SUBJECT: Forwards corrections & clarifications to Amend 23 to FSAR
 Section 8.3 re onsite power sys.Next FSAR amend will be
 revised to include encl corrections.

September 22, 1982
G02-82-800

Subject: NUCLEAR PROJECT NO. 2
FINAL SAFETY ANALYSIS REPORT
SECTION 8.3 CORRECTIONS

8.3 ONSITE POWER SYSTEMS

TYPICAL DIVISION MARKERS

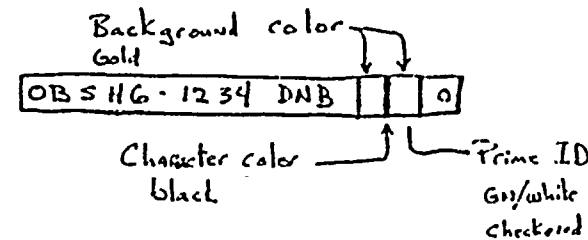
NOTE 1: AN A'1 OR B'2 CABLE SECTION MAY BE TREATED AS NON-CLASS IE. SEE CATEGORY 1B, FIGURE 8.3-43A AND CATEGORY 2B, FIGURE 8.3-43A.

GENERAL AREAS
CROSSOVERS
(SEE NOTE ON FIGURE 8.3-29a)

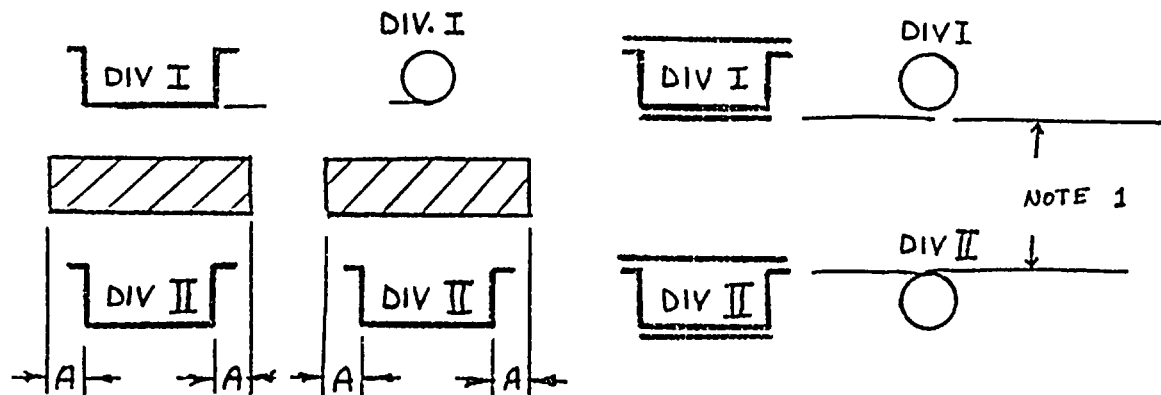
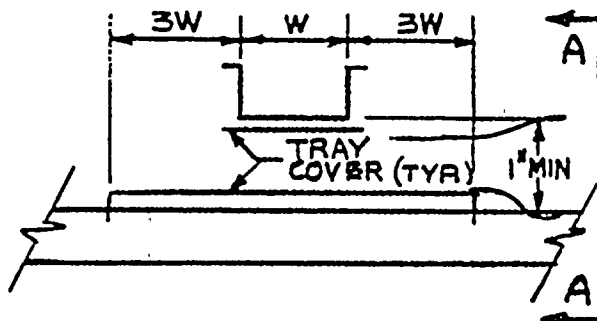
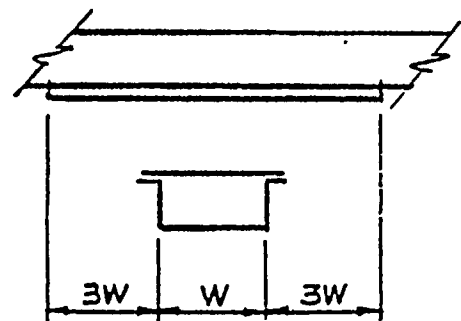
In the case of ^{an} ~~crossovers of enclosed raceways and open trays~~ ^{routed below an} of a redundant division, the minimum separation distance is ^{and a solid bottom or} one inch ^{barrier extending} if the enclosed raceway is below the open tray. ^{12" beyond the} If the enclosed raceway is above the open tray, a one-inch vertical separation and a tray cover extending 12 inches beyond ^{sides of the} the sides of the ~~conduit~~ ^{enclosed raceway is} is required. See Figure 8.3-29d. ^{add. provided for the} ^{open tray.}

FIGURE
 8.3-
 43a

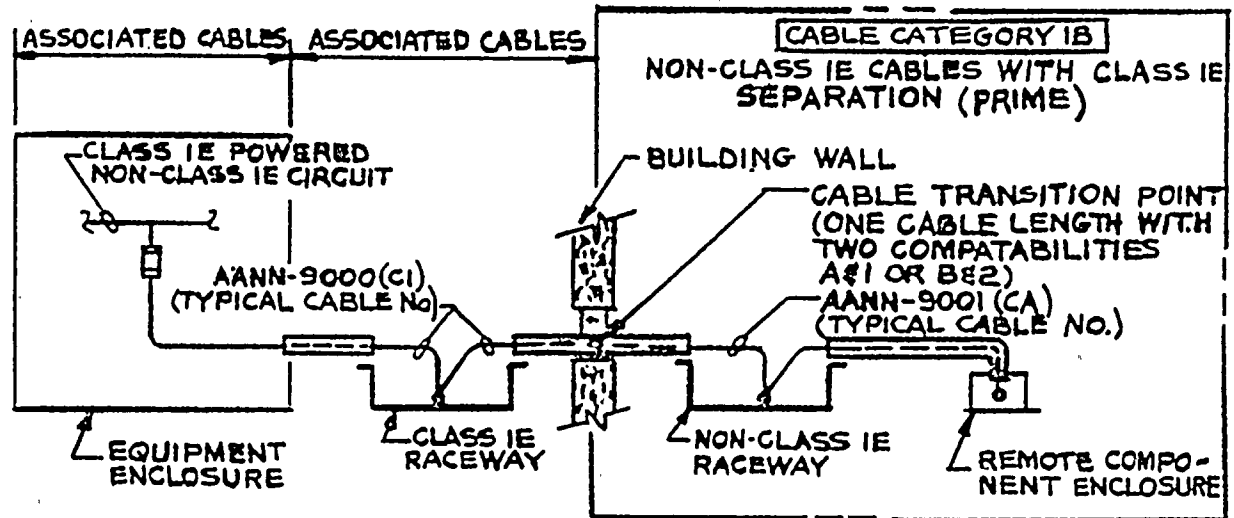
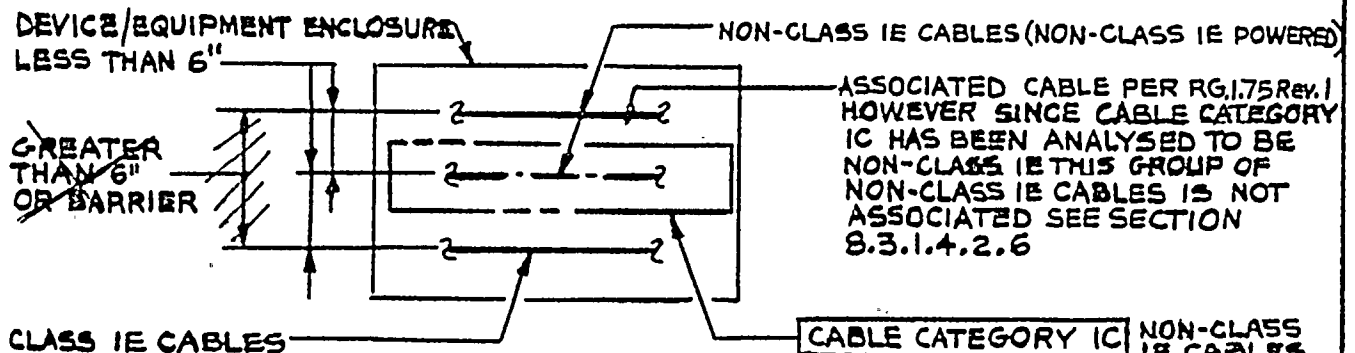
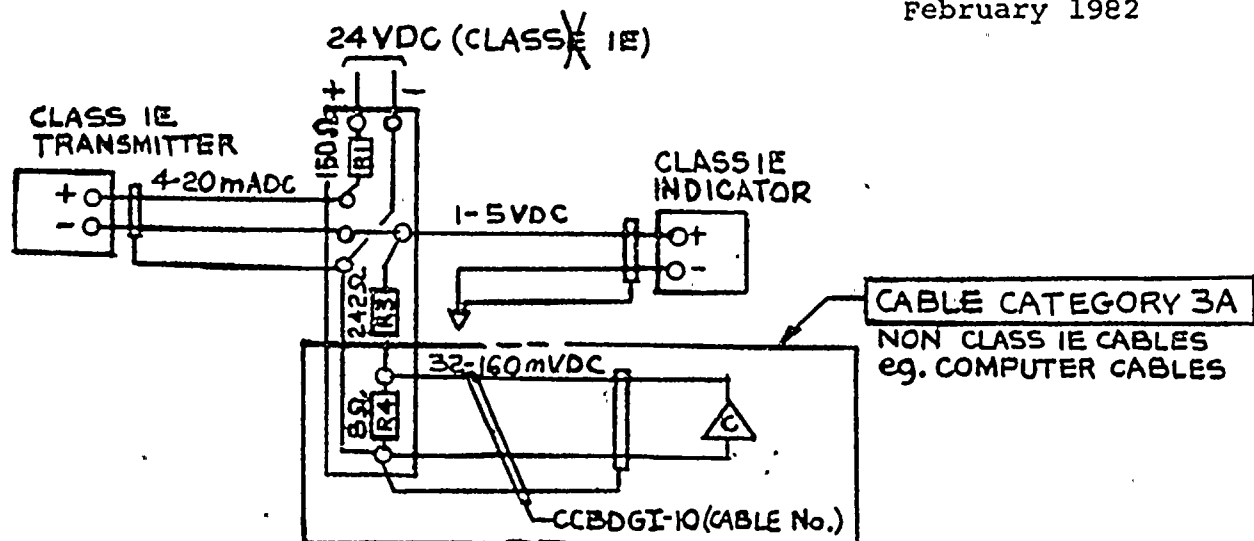
but are associated by proximity inside an enclosure, ~~or become associated with a noncompatible Class 1E division in a downstream raceway or enclosure.~~ See Figure 8.3-43a.
